**CITY OF BROOKSVILLE**  
**REQUEST FOR PROPOSAL**  
**PURCHASE, DELIVERY AND INSTALLATION OF**  
**THREE (3) SEWAGE LIFT STATIONS STANDBY**  
**GENERATORS AT EMERGENCY SHELTERS**  
**PW2019-03**

**ADDENDUM #2**  
**Date Issued – February 22, 2019**

City of Brooksville, Florida  
201 Howell Ave., Ste 300, Brooksville, FL 34601, (352) 942-5767  
Lift Station Generators at Emergency Shelters  
Automatic Transfer Switch Panel Details

SCALE:  
Noted  
Sheet  
9 of 9

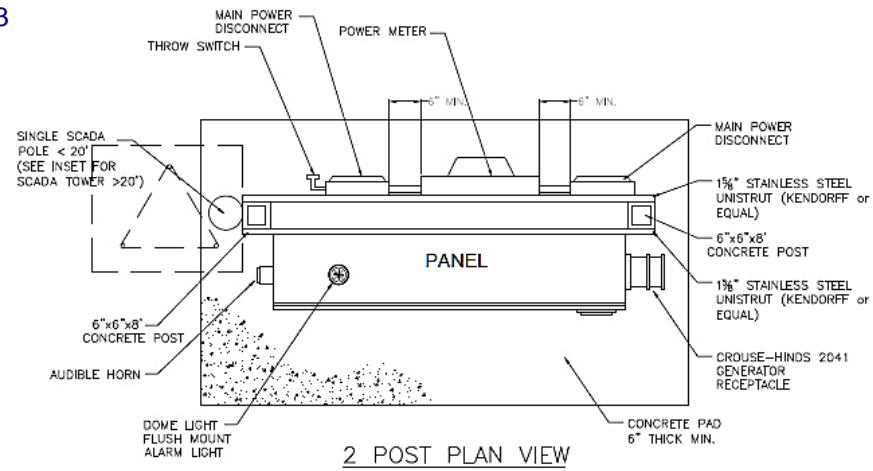
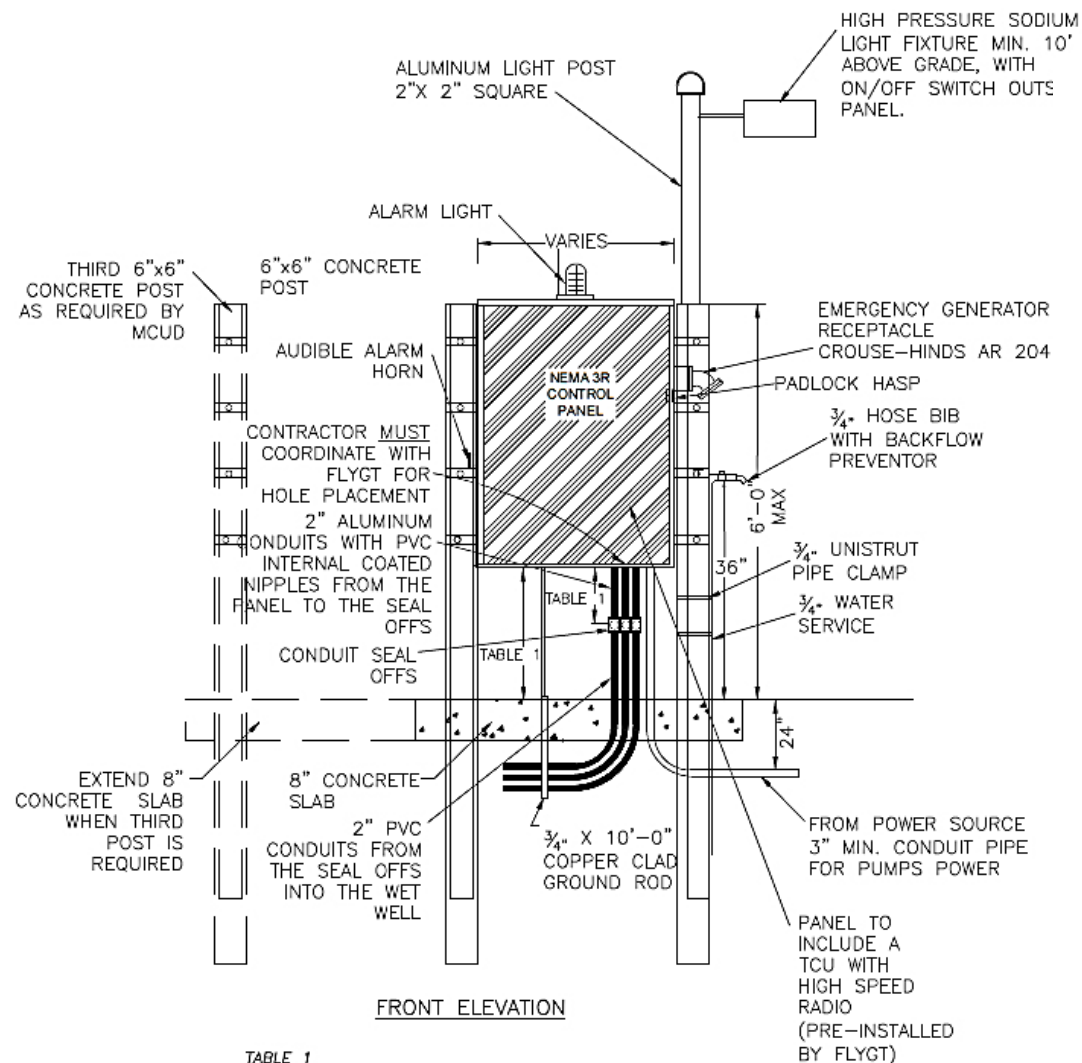
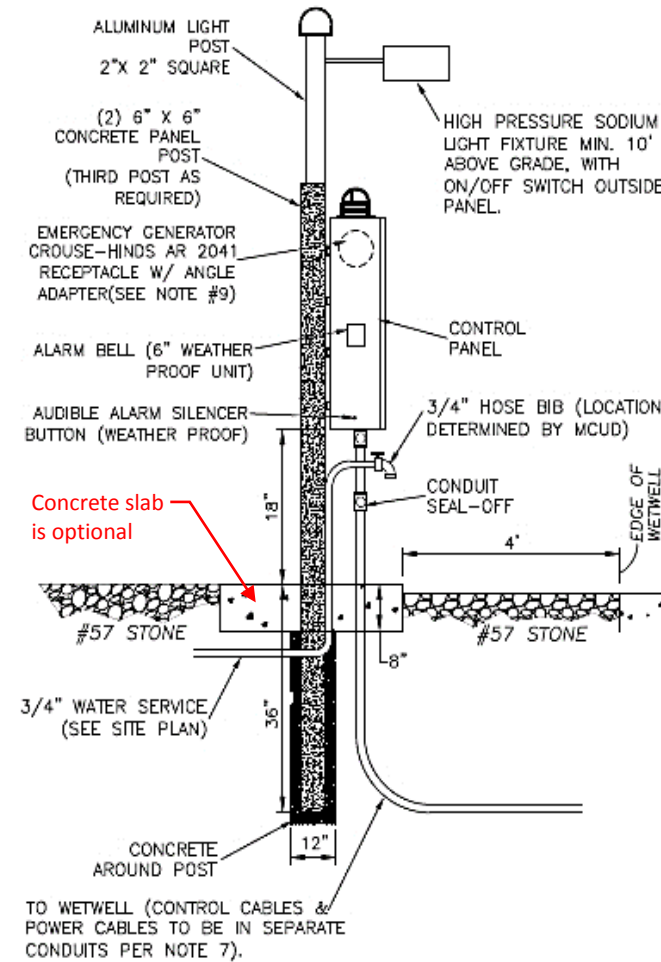
Please confirm that sheet 9 of 9 is only for the design of the support of the ATS.

Please confirm the following (see red responses to each):

- a. Note #1 can be changed to two posts **Yes, two posts are acceptable.**
- b. Notes 3 and 4 should be amended to the width of 2 posts and the ATS. **Notes 3 and 4 are amended below. The revised drawing is reissued and attached.**

3. The control panel will be mounted on 12 gauge, 1-5/8" aluminum or stainless steel strut, which spans all ~~three (3)~~ posts, as needed. The new control panel will be mounted to the right side (depending on site requirements) of the equipment mounting stand, leaving room on the left half of the stand for future equipment.

4. The mounting strut will be 8'-0" long ~~with one (1) center post for a three post configuration~~. The control panel mounting strut will be fastened to the 6" posts using 3/8" x 3" stainless steel sleeve anchors. All cut ends, struts and drilled holes will be deburred. All bolts, nuts and washers shall be stainless steel. Strut nuts (spring nuts) shall be stainless steel.

- c. Notes #7, 8 and 9 do not apply. **Notes 7, 8 and 9 are herein deleted. The revised drawing is reissued and attached.**
- d. Do you want the light fixture shown? **Yes, the light fixture is required.**

- e. Do you want the little slab shown? **The slab at the base of the control panel is optional for the contractor.**

**Yes the support design is intended solely for the Automatic Transfer Switch.**

3. The control panel will be mounted on 12 gauge, 1-5/8" aluminum or stainless steel strut, which spans all ~~three (3)~~ posts, as needed. The new control panel will be mounted to the right side (depending on site requirements) of the equipment mounting stand, leaving room on the left half of the stand for future equipment.

4. The mounting strut will be 8'-0" long with one (1) center post for a three post configuration. The control panel mounting strut will be fastened to the 6" posts using 3/8" x 3" stainless steel sleeve anchors. All cut ends, struts and drilled holes will be deburred. All bolts, nuts and washers shall be stainless steel. Strut nuts (spring nuts) shall be stainless steel.
